**RE: RESPONSE TO ECOLOGY COMMENTS ON TECHNICAL MEMORANDUM,
SUPPLEMENTAL SUBSURFACE INVESTIGATION AND FOUNDATION
ELEMENTS
BLOCK 38 WEST SITE
500 THROUGH 536 WESTLAKE AVENUE NORTH
SEATTLE, WASHINGTON
FARALLON PN: 397-019**

Attachment A**Block 38 West Site, Seattle, WA****Agency Review Comments****Document:** Technical Memorandum: *Supplemental Subsurface Investigation and Foundation Elements* (Farallon, June 15, 2020)**Comment Date:** August 12, 2020**Response Comments Date:** September 2, 2020

CROSS SECTION C-C'
BLOCK 38 WEST SITE
SEATTLE, WASHINGTON

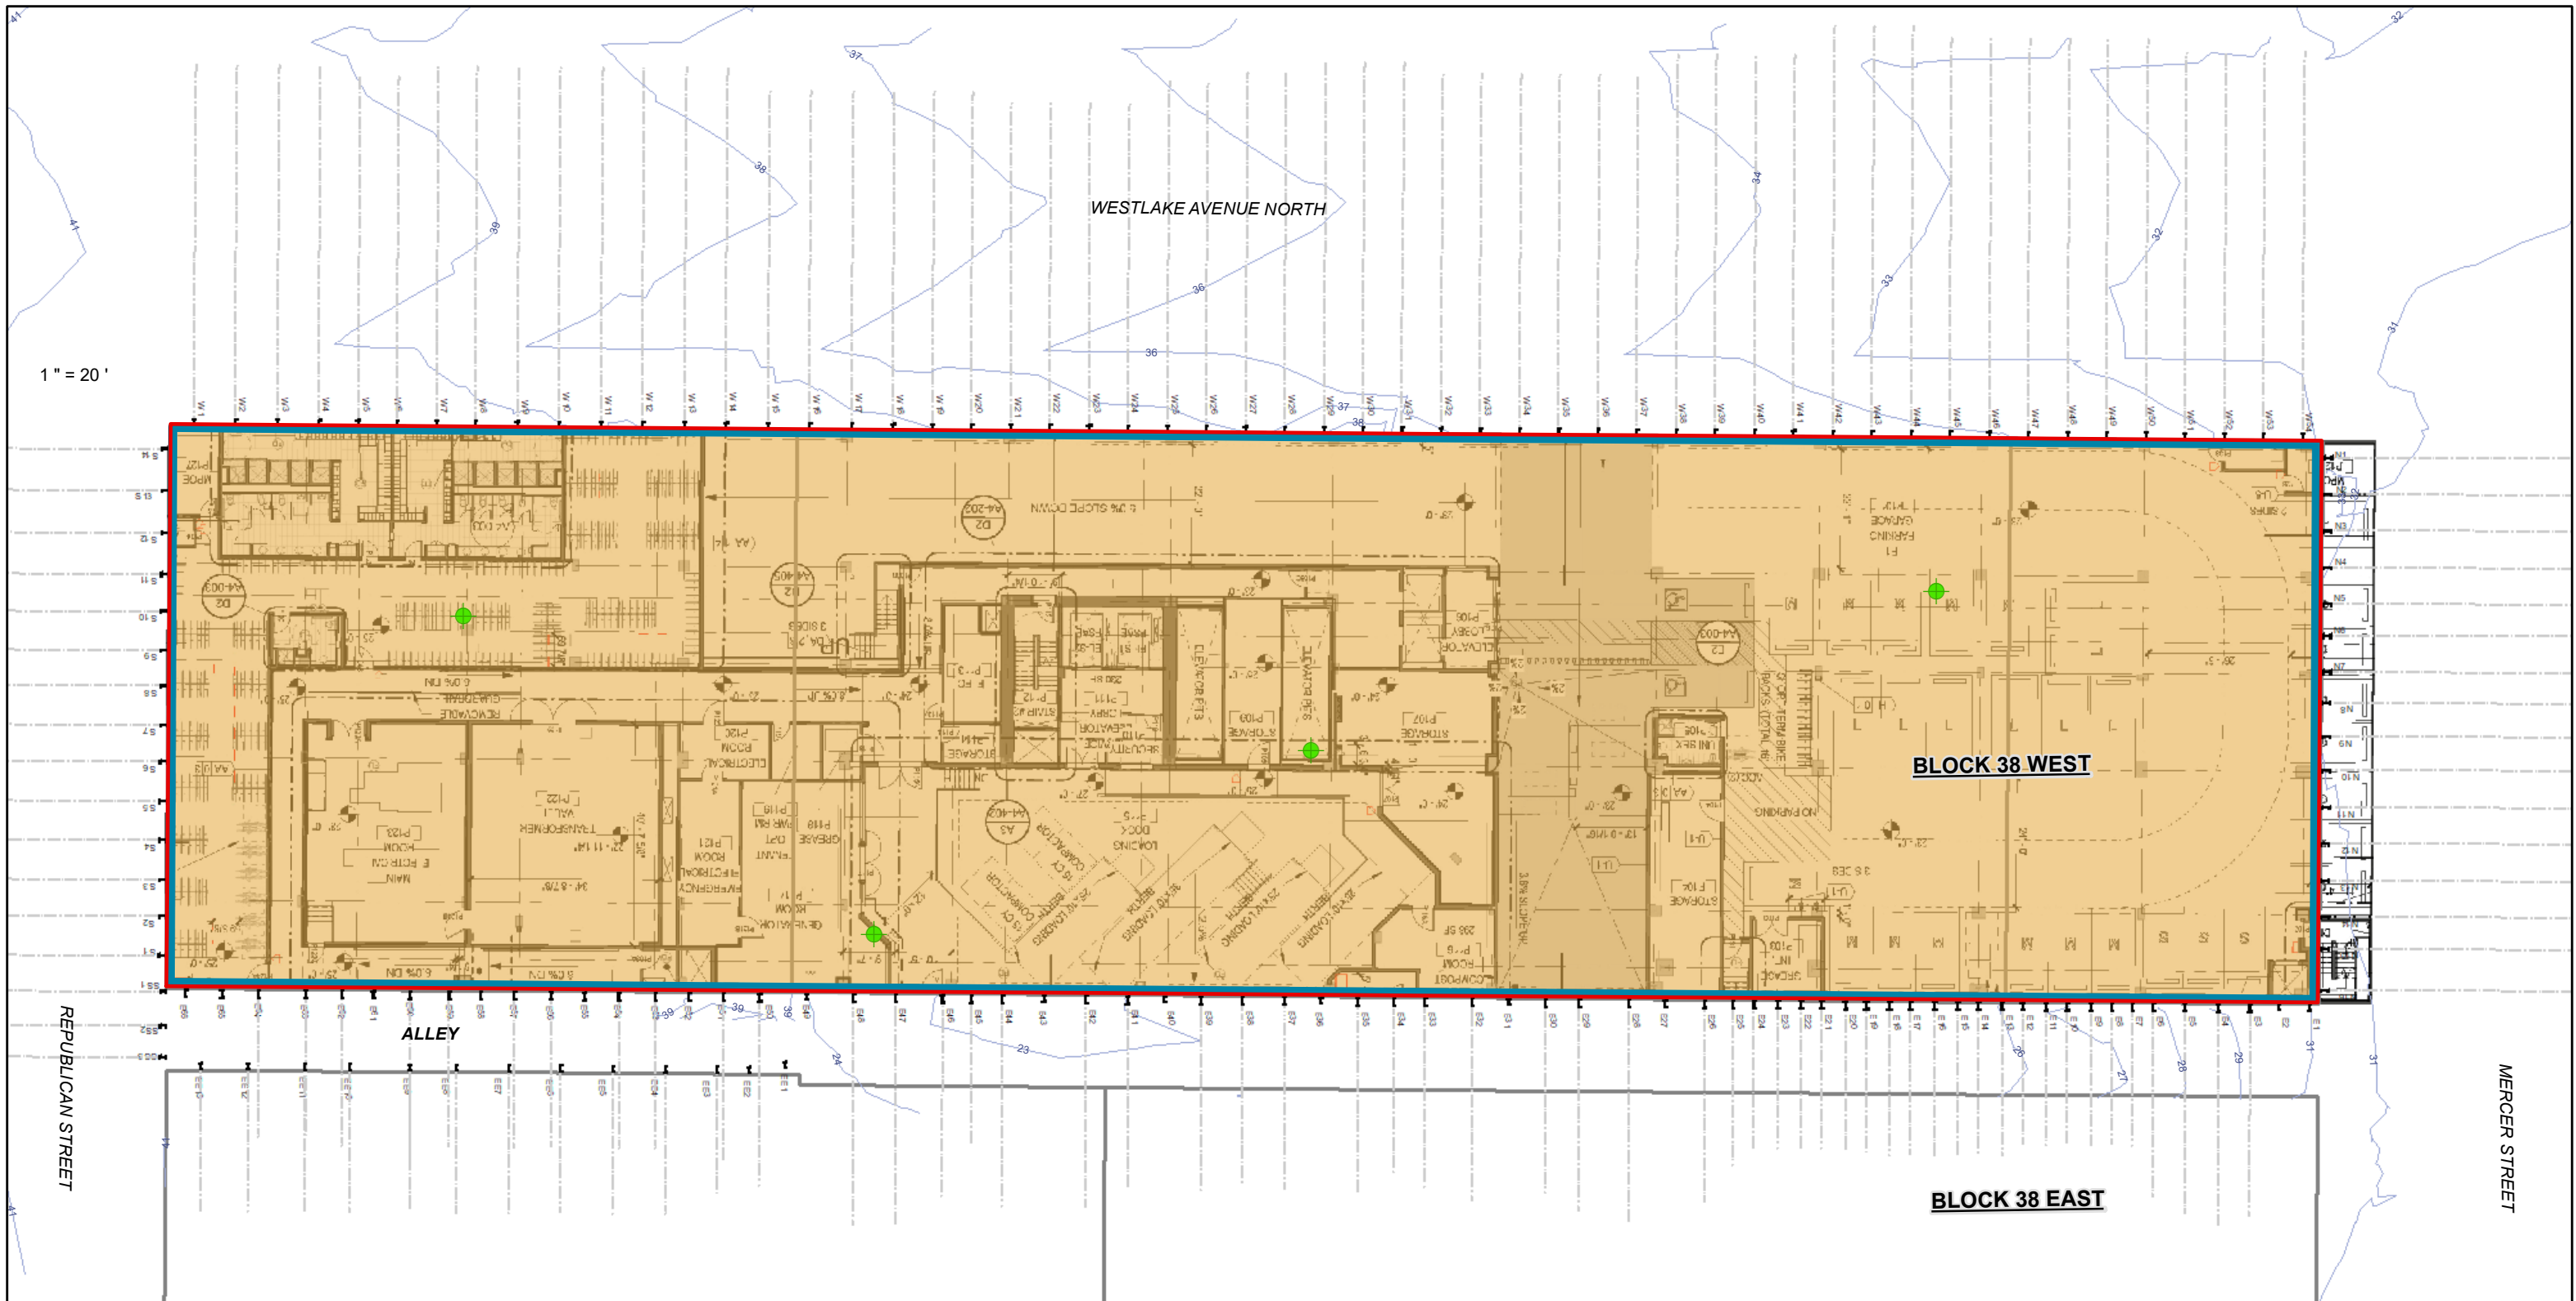
Section and Paragraph	Page No.	Review Comment	Response to Comments
Soil, 1 st paragraph	3	Figures 4 through 9 include other data outside of the eastern sidewall of the Block 38 West excavation, the alley, and the western sidewall of the Block 38 East excavation. Please note that, through this review, Ecology is not evaluating the sufficiency of that data for the purpose of a remedial investigation.	Comment noted.
Soil, 2 nd paragraph	3	What is the approximate depth interval (ft bgs, relative to the alley) for the soil impacts at the eastern sidewall of the Block 38 West excavation? This would be helpful to have in addition to the elevation information for reference purposes.	Tables 1 through 3 provide both depth below ground surface and elevation for soil samples collected from the eastern sidewall of the Block 38 West Property and in the alley. Assuming an approximate surface elevation of 26 to 23 feet NAVD88 from north to central portion of alley, soil impacts were detected from 2 to 10 feet bgs. Attachment B provides existing cross-sections C-C' and D-D', Figures 19 and 20 from the Agency Review Draft RI Work Plan for reference.

Supplemental Subsurface Investigation, 1 st paragraph	6	What are the approximate elevations of the 5- to 10-foot thick zone of impacted soil extending across the alley? Is it at ~25 to 15 ft NAVD88? A cross section would be useful to illustrate this zone.	Correct, approximately 25 to 15 feet NAVD88. Attachment B provides existing cross-sections C-C' and D-D', and Figures 19 and 20 from the Agency Review Draft RI Work Plan are

Section and Paragraph	Page No.	Review Comment	Response to Comments
			provided for reference. The cross sections extend east of the Block 38 West Property into the alley.
Supplemental Subsurface Investigation, 2 nd paragraph	6	<p>This is the first mention of metals-impacted soil that needs to be investigated. Metals weren't discussed in the data gaps section and should have been included on a figure.</p> <p>According to the data in Table 3, the elevated metals concentrations were generally at elevation 22', and concentrations were below the screening levels at elevation 20' and lower. Similar conditions observed for other COCs. During the alley supplemental investigation, you should also sample and analyze soil at the 22'-23' elevation as well as the 20' and deeper elevations.</p>	<p>During a conference call on August 21, 2020, Ecology and Farallon discussed the fact that metals are not COCs for the Block 38 West Site. Metals analyses will support waste characterization for disposal purposes.</p> <p>However, based on Ecology's request, additional select analytes in soil will be analyzed to support Ecology's understanding of potential impacts in the alley and to what extent those impacts will be removed by the alley improvements associated with the Block 38 West Property construction project.</p>

FIGURE 22
 SITE PLAN - VAPOR BARRIER EXTENT
 BLOCK 38 WEST SITE
 SEATTLE, WASHINGTON

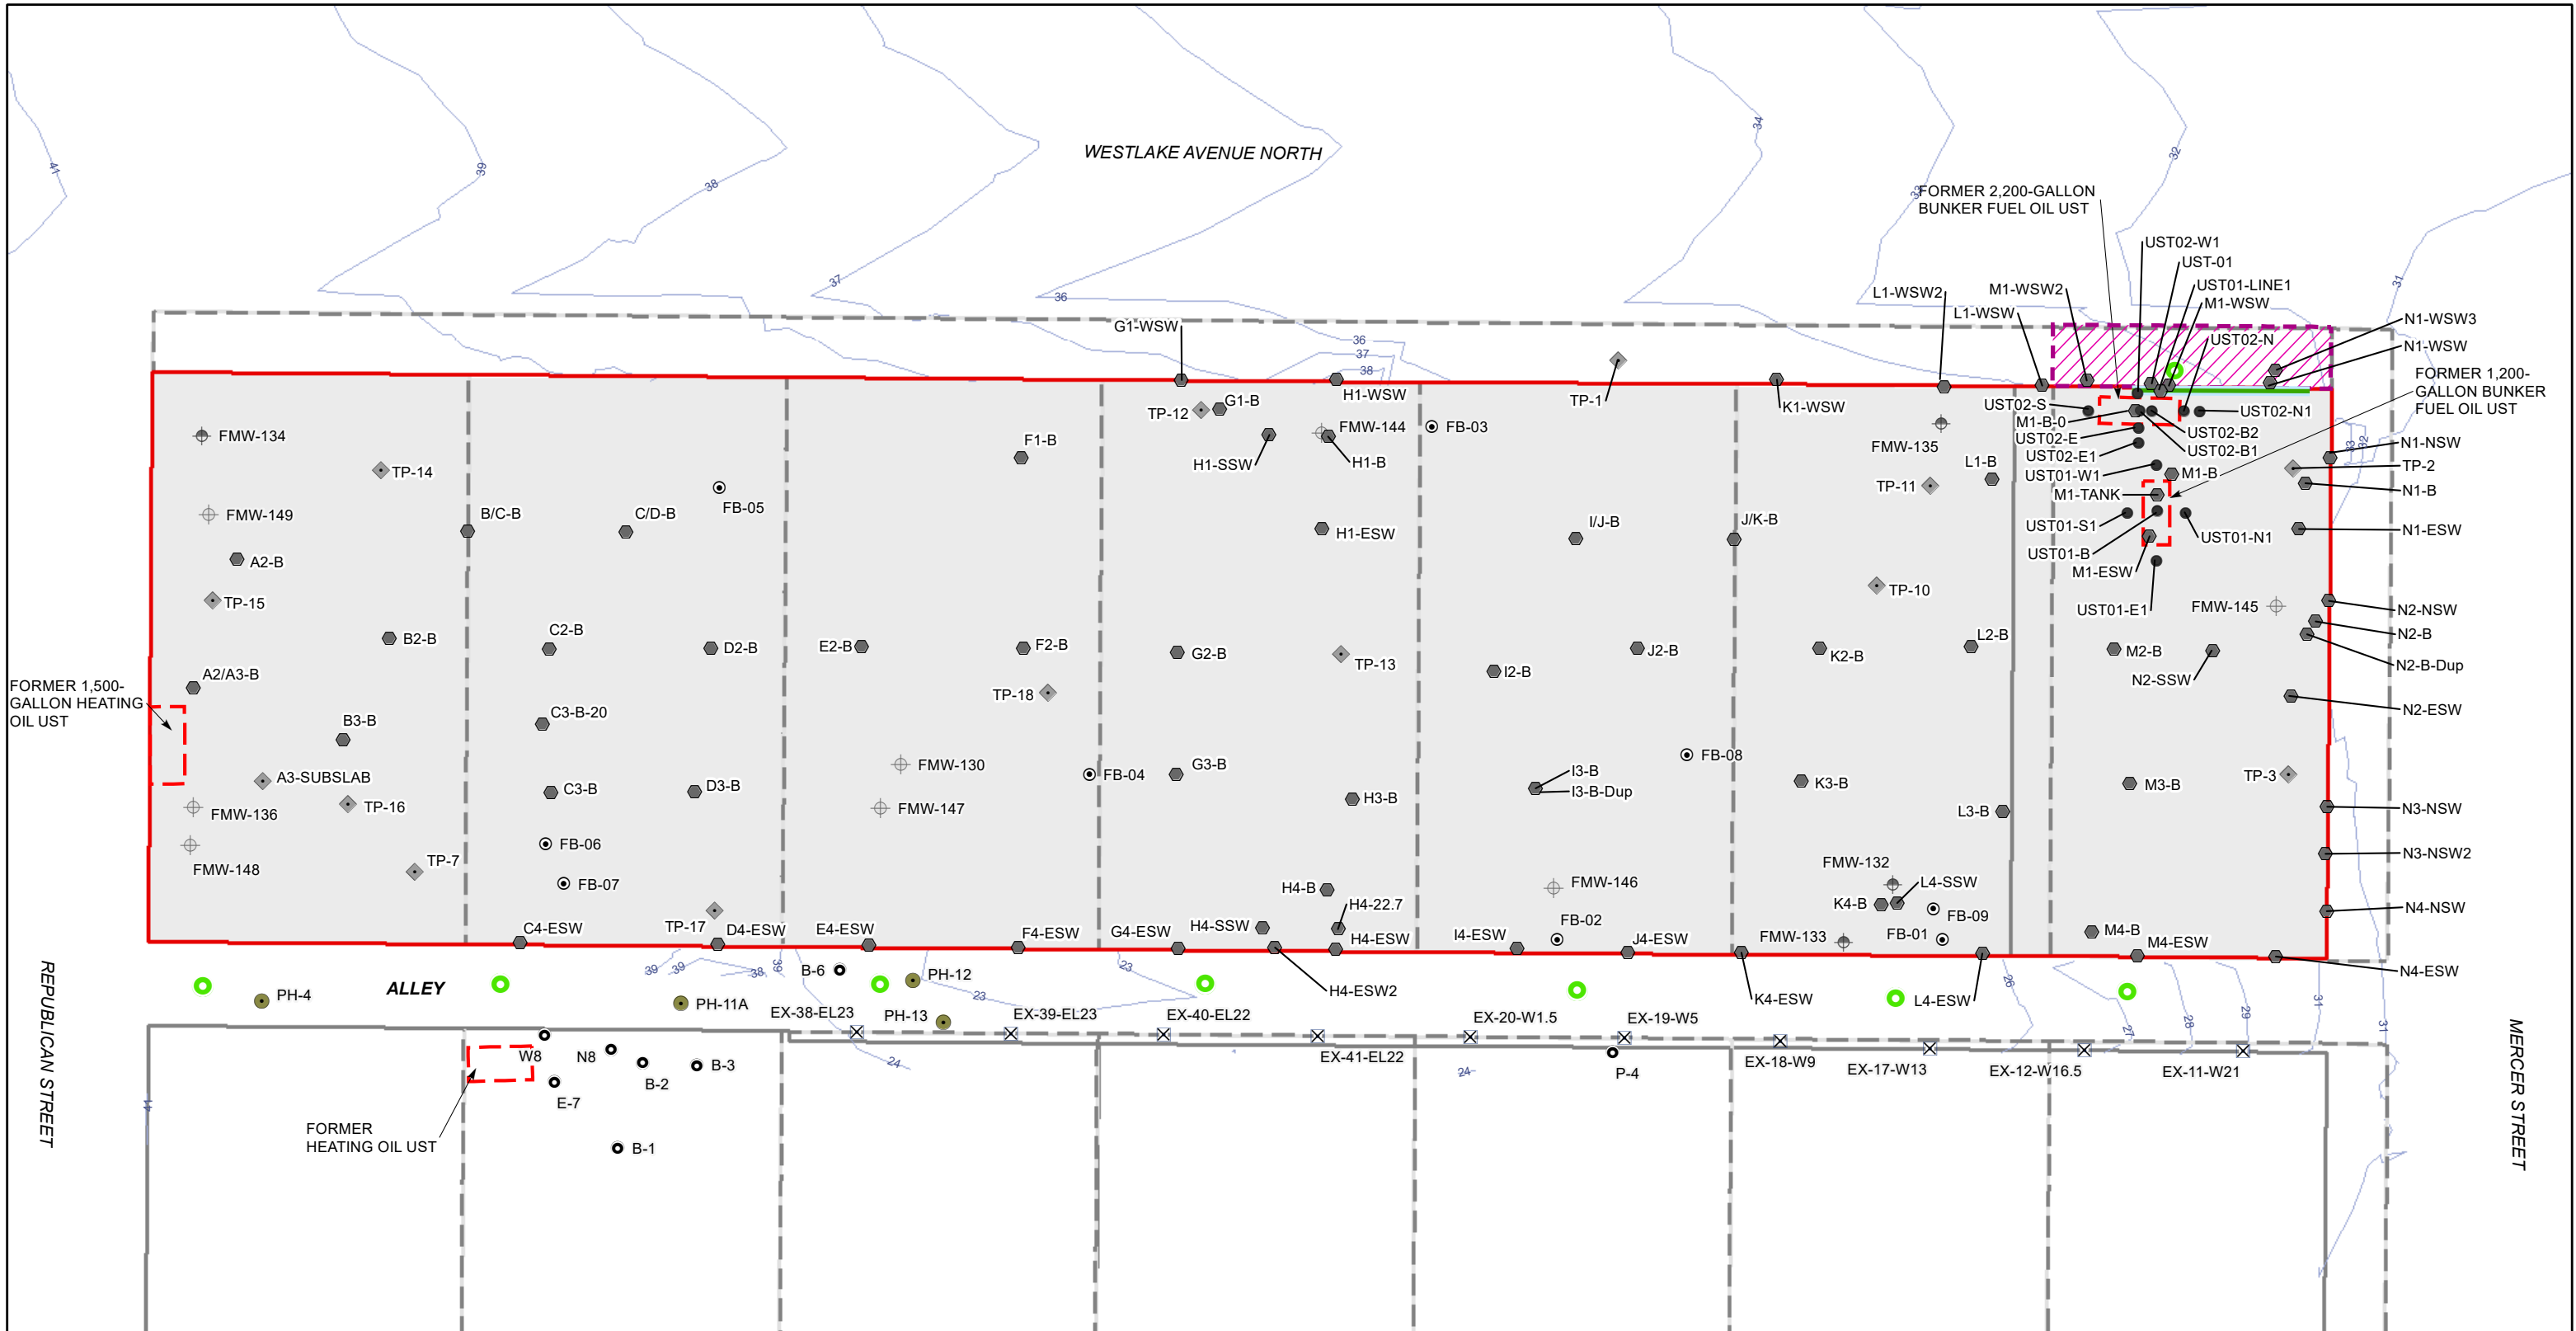
Building Foundation Elements	7	Drago Wrap specifications indicate that it protects against VI. However, the attached design figures indicate that the area covered by the Drago Wrap is not "all encompassing". Please demonstrate with a figure the extent covered by the Drago Wrap, or the updated	The building design was revised to wrap or encompass the entire building foundation with the Drago Wrap. Attachment B provides the vertical and lateral extent of the Drago Wrap vapor barrier, Figure 22 from the Agency Review Draft RI Work Plan.

Section and Paragraph	Page No.	Review Comment	Response to Comments
		membrane, if that is the case. We can't give approval of this work plan until we receive an updated figure showing that.	
Building Foundation Elements	3	While the Hycrete 1000 System may be suitable as a water vapor barrier, I don't believe there are specifications that qualify it as a chemical vapor barrier. If this is to be used as a barrier to prevent intrusion of VOC vapors, you will need to provide Ecology with the manufacturer's chemical vapor resistance specifications for this product to demonstrate that it is protective.	Please see comment above. Based on correspondence with the manufacturer the building design was revised to include a vapor barrier around the entire building foundation, including both horizontal and vertical foundation elements.
Figure 9 (cPAHs in soil)		I disagree with the inferred extent of cPAHs that had exceeded the SL on the Block 38 West property. Conditions in the area between FMW-130 and the eastern property boundary are unknown with respect to cPAHs at the impacted elevation of ~20-ft NAVD88. Soil from this area (including the sidewalls) was not analyzed for cPAHs at elevations shallower than 15 ft NAVD88. Can you provide more information to justify the cPAH boundary that is shown?	City Investors is amenable to updating the extent of the cPAH impacts east to sidewall sample, D4-ESW.
